PAVEMENT SCOPE CLARIFICATION EXHIBIT

ORANGE COUNTY UTILITIES OPERATIONS CENTER
8100 PRESIDENTS DRIVE
ORLANDO, FLORIDA

CONFORMED SET

SHEET NUMBER
C-202

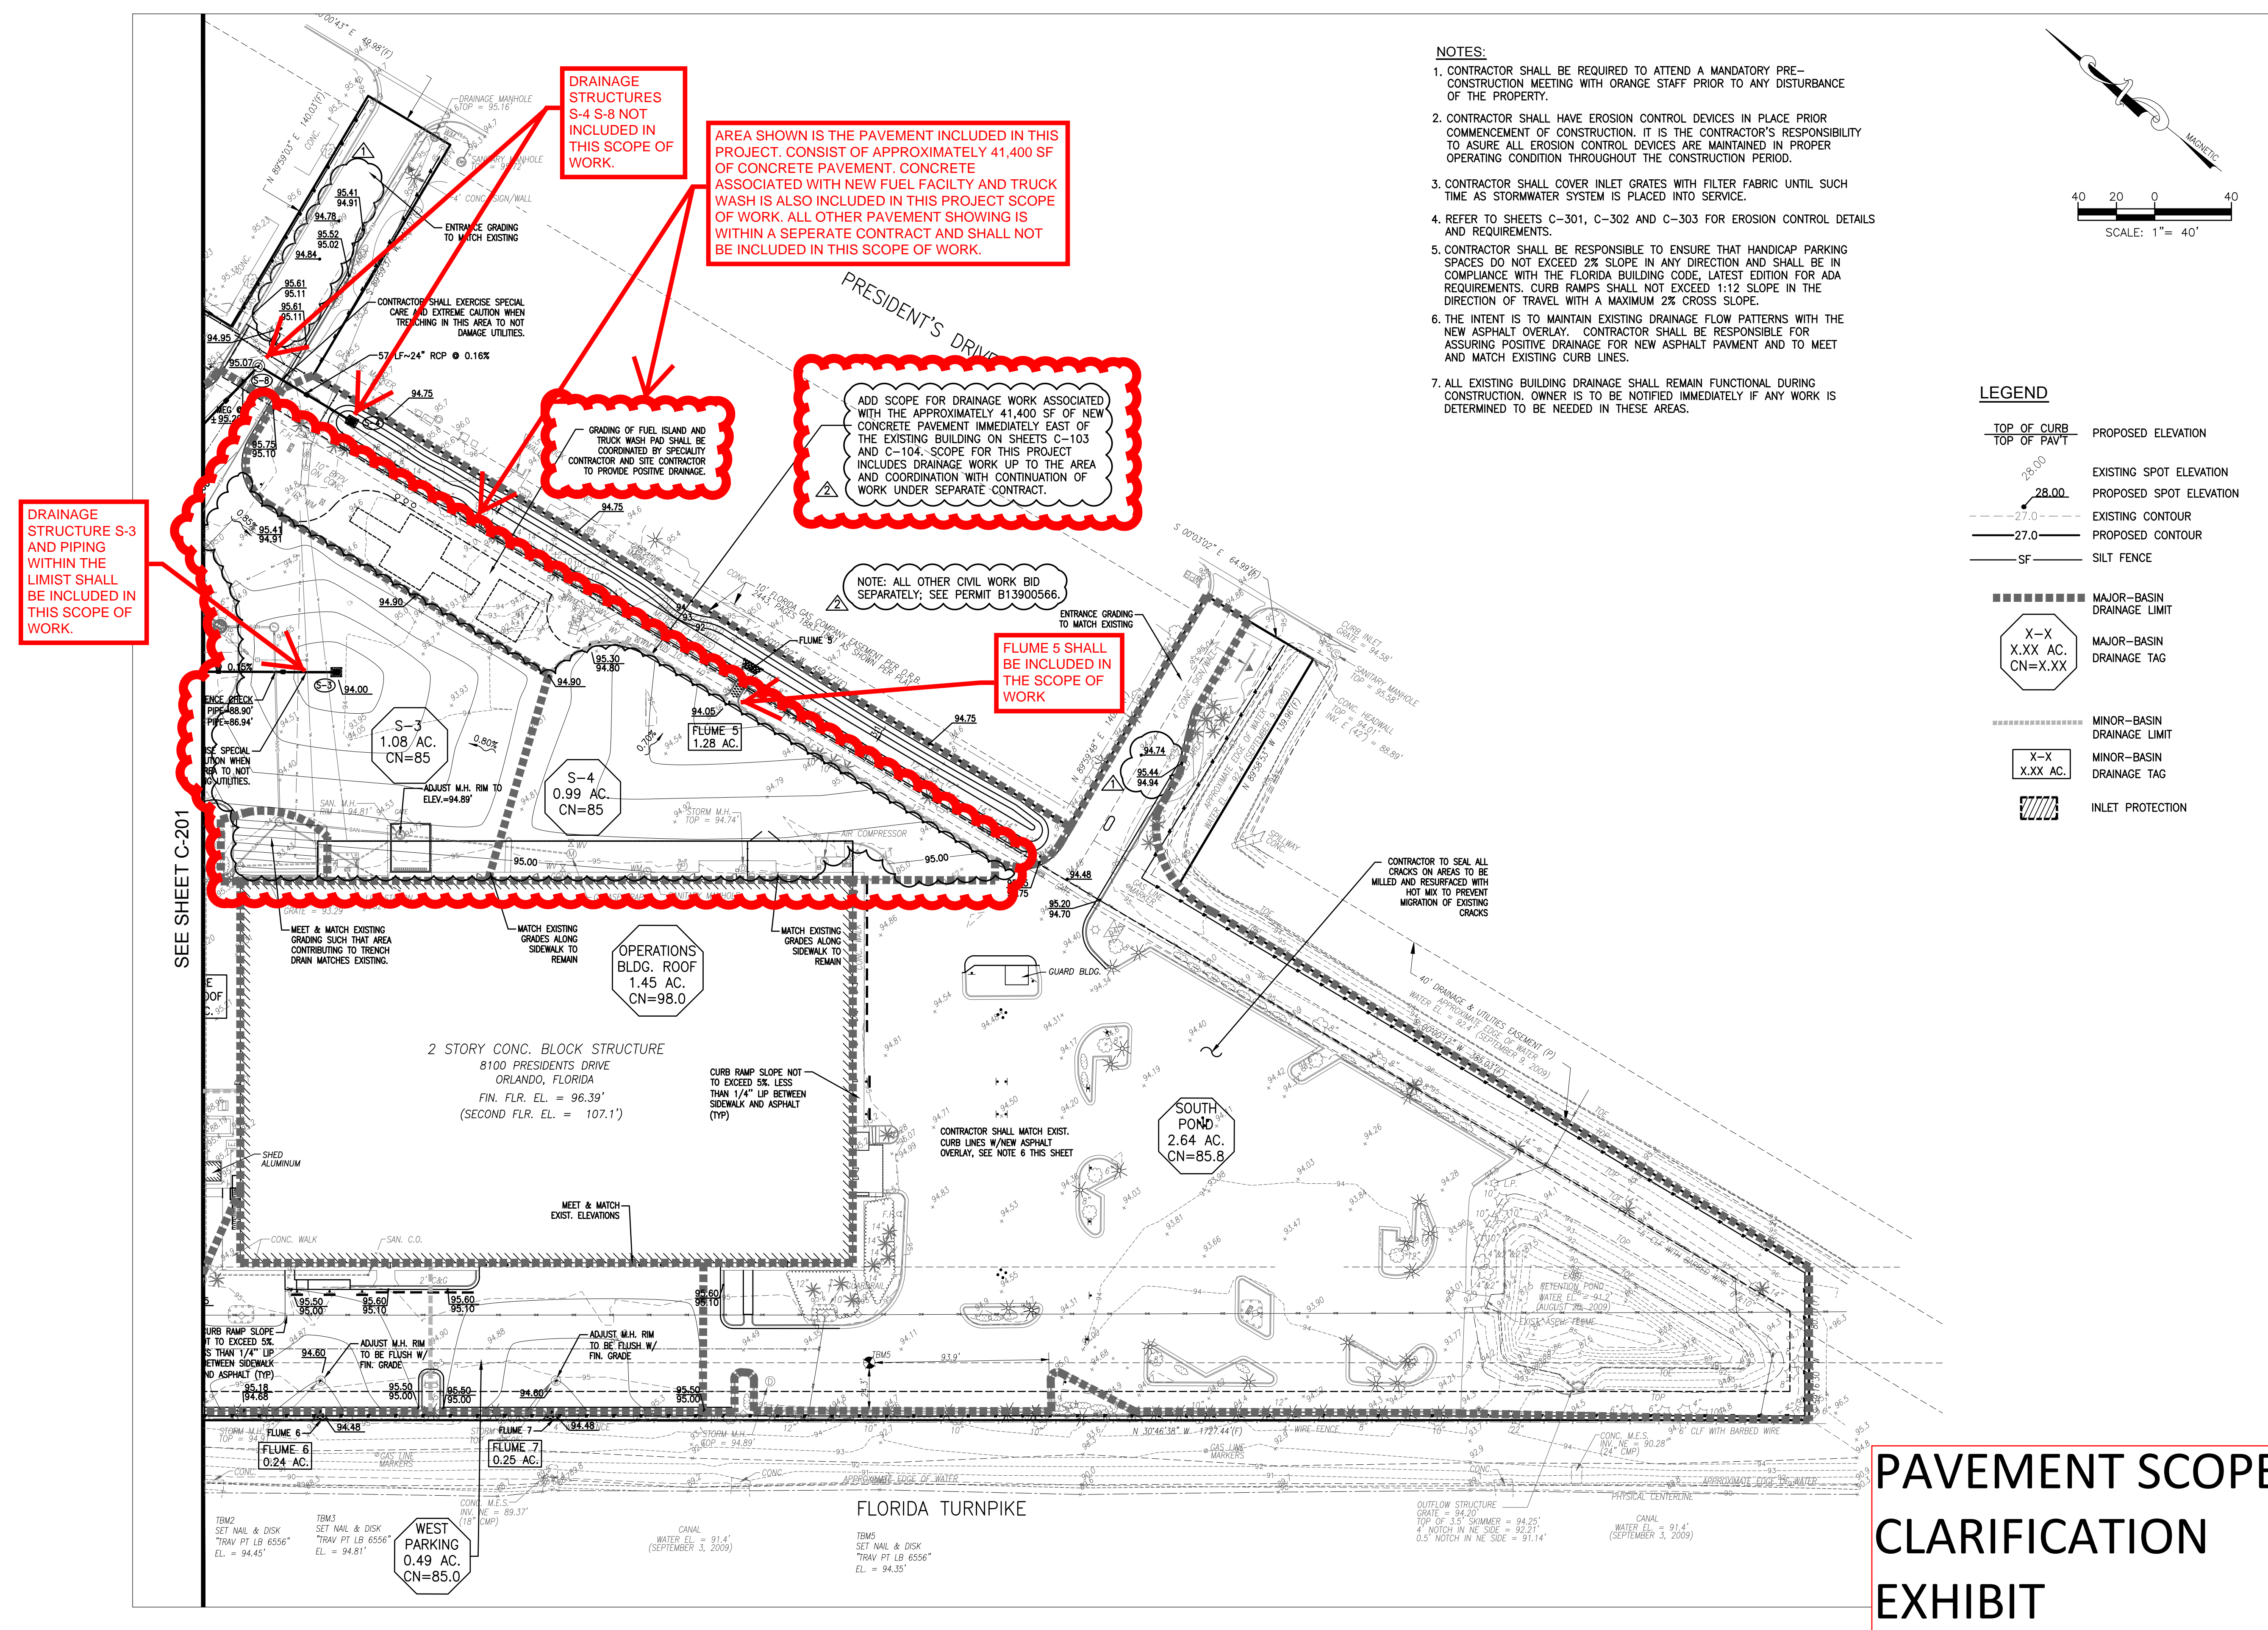
DRAINAGE STRUCTURES S-4 S-8 NOT INCLUDED IN THIS SCOPE OF WORK.

AREA SHOWN IS THE PAVEMENT INCLUDED IN THIS PROJECT. CONSIST OF APPROXIMATELY 41,400 SF OF CONCRETE PAVEMENT. CONCRETE ASSOCIATED WITH NEW FUEL FACILITY AND TRUCK WASH IS ALSO INCLUDED IN THIS PROJECT SCOPE OF WORK. ALL OTHER PAVEMENT SHOWING IS WITHIN A SEPERATE CONTRACT AND SHALL NOT BE INCLUDED IN THIS SCOPE OF WORK.

ADD SCOPE FOR DRAINAGE WORK ASSOCIATED WITH THE APPROXIMATELY 41,400 SF OF NEW CONCRETE PAVEMENT IMMEDIATELY EAST OF THE EXISTING BUILDING ON SHEETS C-103 AND C-104. SCOPE FOR THIS PROJECT INCLUDES DRAINAGE WORK UP TO THE AREA AND COORDINATION WITH CONTINUATION OF WORK UNDER SEPERATE CONTRACT.

DRAINAGE STRUCTURE S-3 AND PIPING WITHIN THE LIMITS SHALL BE INCLUDED IN THIS SCOPE OF WORK.

FLUME 5 SHALL BE INCLUDED IN THE SCOPE OF WORK
